Access Compliance Report Public Rights-of-Way (Pedestrian Signals)

Main Street: CROWN_VALLEY_PKWY Cross Street: CROWN_VALLEY_PKWY Location: NE

ADA ID: SGRK211026120026 Signal Type: One Push Button-Non APS Overall Compliance: No Severity Scores: BTN 1: 35 BTN 2: N/A No BTN: N/A

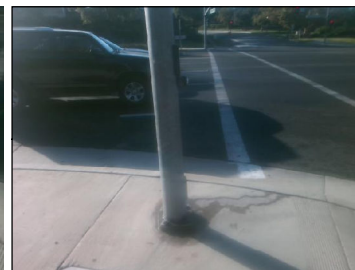
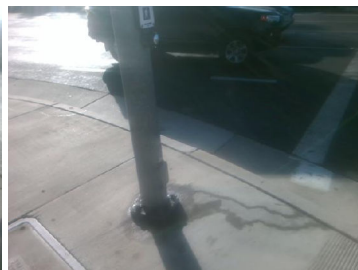
OC Std/PROW: R404.2, MUTCD 4e.08

Possible Solutions: Replace Signal Push Button With APS Button. Remove and Replace Clear Space.
